CLOSURE PLAN
FOR
SOLID WASTE MANAGEMENT FACILITY
VANDEMARK CHEMICAL CO. INC.
LOCKPORT, N.Y.

JULY 1, 1982

As agreed in our telephone conversations of August 4, I am forwarding comments on the closure plan for the the Van De Mark Chemical Company landfill (EPA I.D. Number NYT370011249), so that you can consolidate them with your own comments and those from your Albany office into one letter to Van De Mark. This will enable Van De Mark to address the concerns of both New York State Department of Environmental Conservation (DEC) and Environmental Protection Agency (EPA) at the same time by sending both Agencies a copy of the response to your letter. EPA's concerns which should be addressed in your letter are as follows:

The closure plan for the above facility has been reviewed by this office, our Albany office, and by the Region II office of the U.S. Environmental Protection Agency. The following is a summary of the comments that have been made by the various parties:

DESIGNED BY	SOMERSET RAILROAD CORPORATION		SCALE
DRAWN BY	REVIEWED BY	DATE	
CHECKED BY			JOB NO. 14818
IN CHARGE	BECHTEL ASSOCIATES PROFESSIONAL CORPORATION		FIGURE 2
DATE

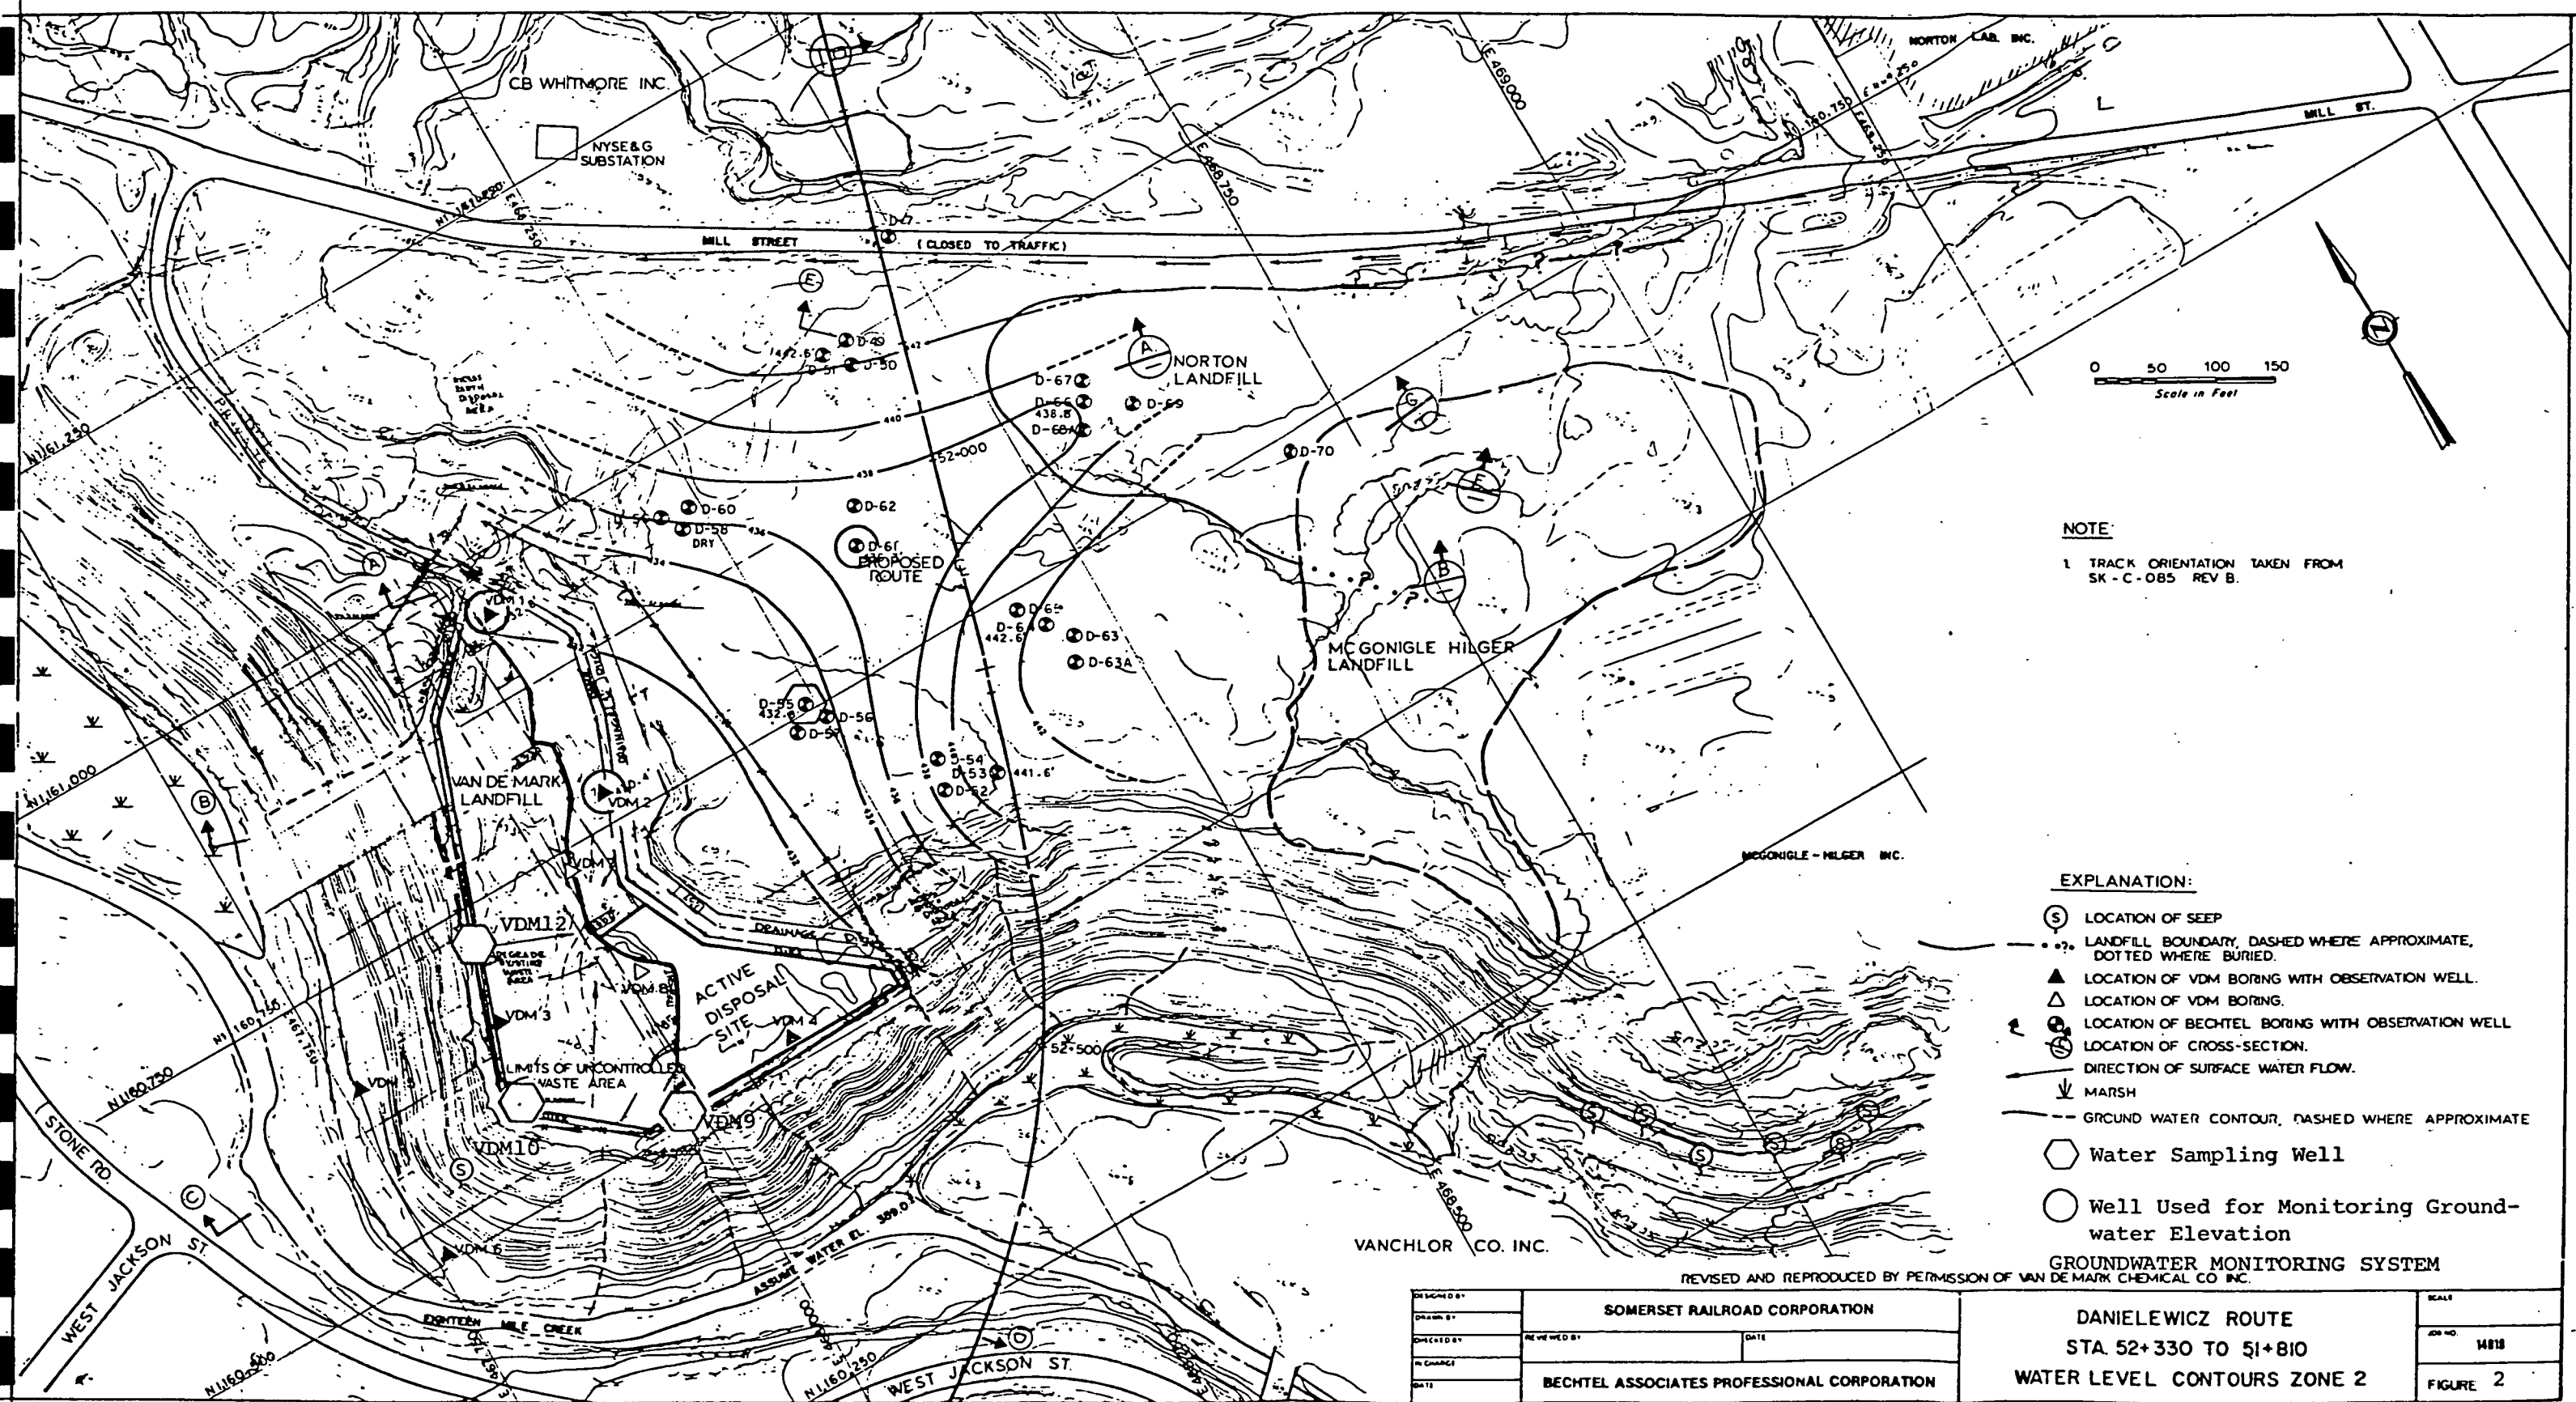
- ✓ c. Page 3 section 2.0 indicated in the first paragraph that the ground water elevations decrease from west to east, however, the elevations in figure 2 indicate an increase from west to east. Further, the reference to well B-55 should be changed to D-55.

b. Page 2, Section 1.2 - The last paragraph on this page indicates that Part 360.8(c)(5) requires three (3) downgradient and one (1) upgradient monitoring wells in the uppermost aquifer. Three (3) new downgradient wells will be installed along the northeast edge of the landfill (figure 2) and existing well B-55 will be used as the upgradient well. However, Part 360.8(c)(5) requires a minimum of three downgradient wells and it is recommended that an additional well be installed along the western edge of the landfill approximately equidistant between VDM1 and proposed VDM 12. The proposed downgradient wells will not be installed along the northeast edge of the landfill as described. They will be installed along the southwestern or western edge of the landfill. Well D-55, as depicted on Figure 2, will be used as the upgradient well, not well B-55.

c. Page 3, Section 2.0 - In the first paragraph references to well B-55 should be changed to D-55. In this same paragraph it is stated that groundwater elevations decrease from west to east, however, the groundwater elevations on Figure 2 depict an increase from west to east.

DANIELEWICZ ROUTE
STA 52+330 TO 51+810
WATER LEVEL CONTOURS ZONE 2

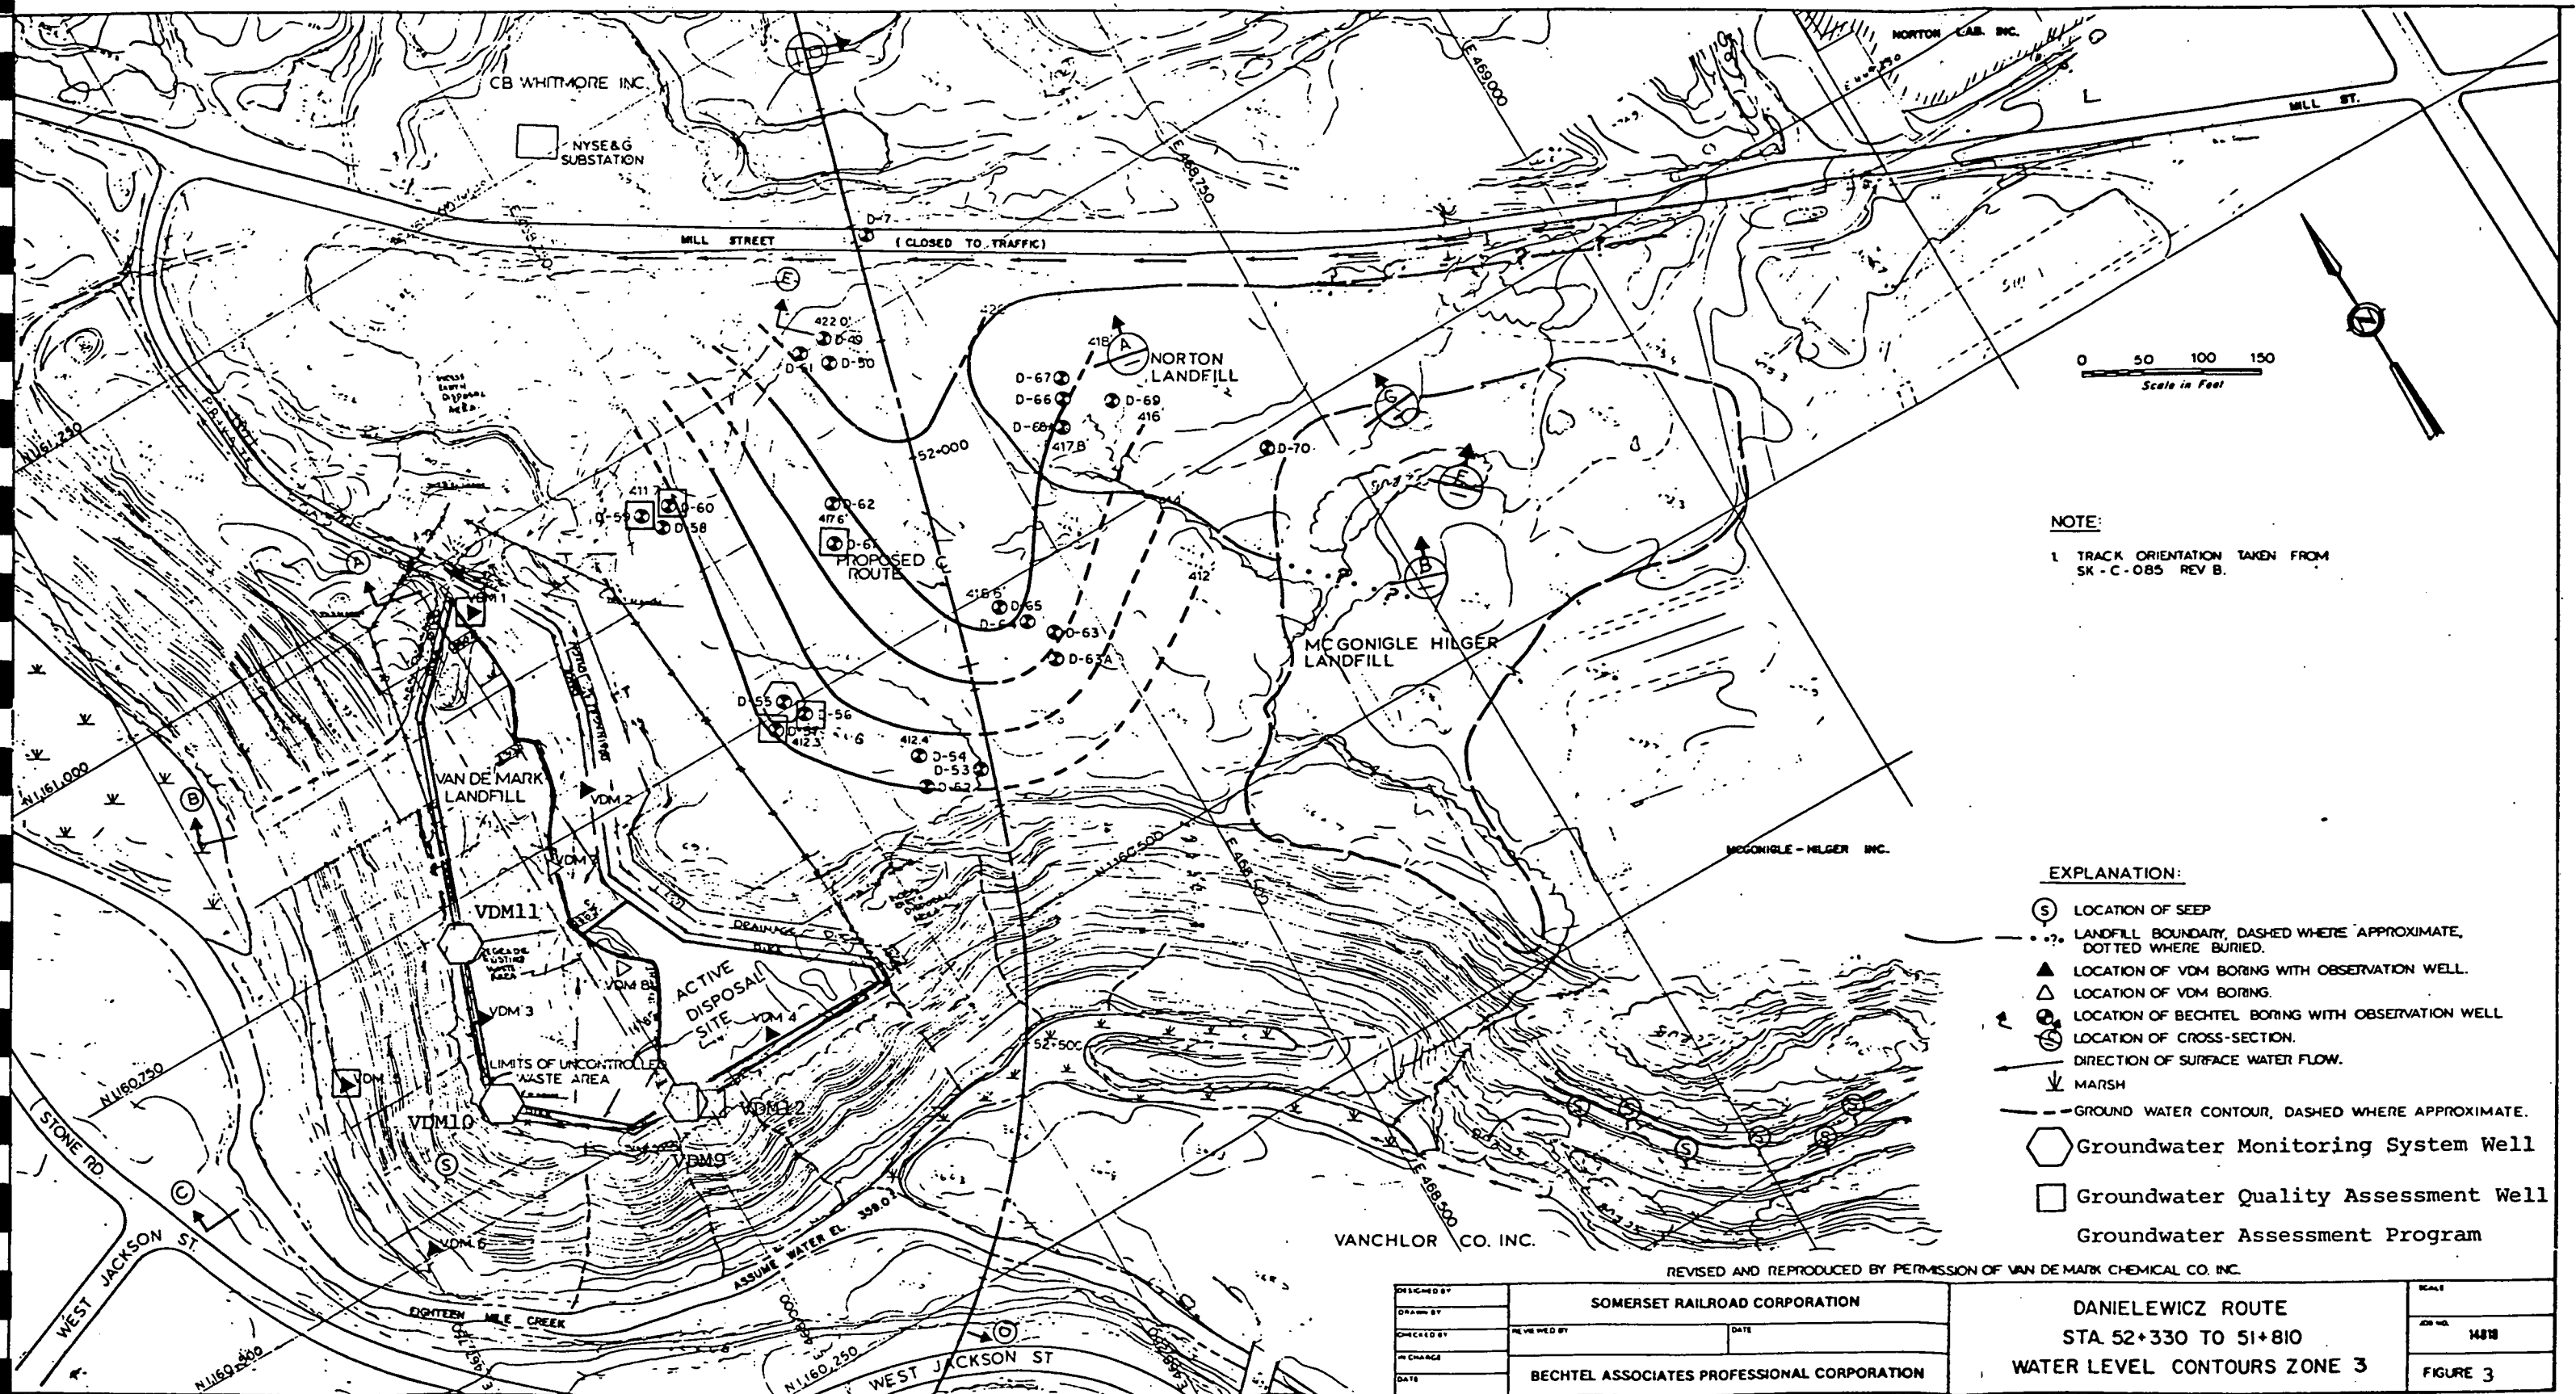
7 h. In figures 2 and 3 of the report, VDM 12 is shown at different locations.
8. The closure plan neglects to discuss the uses of 18-Mile Creek and the surrounding land which could be impacted in the event that there is a release of acidic leachate from the site. A description of the resources which could possibly be impacted by the landfill should be provided.
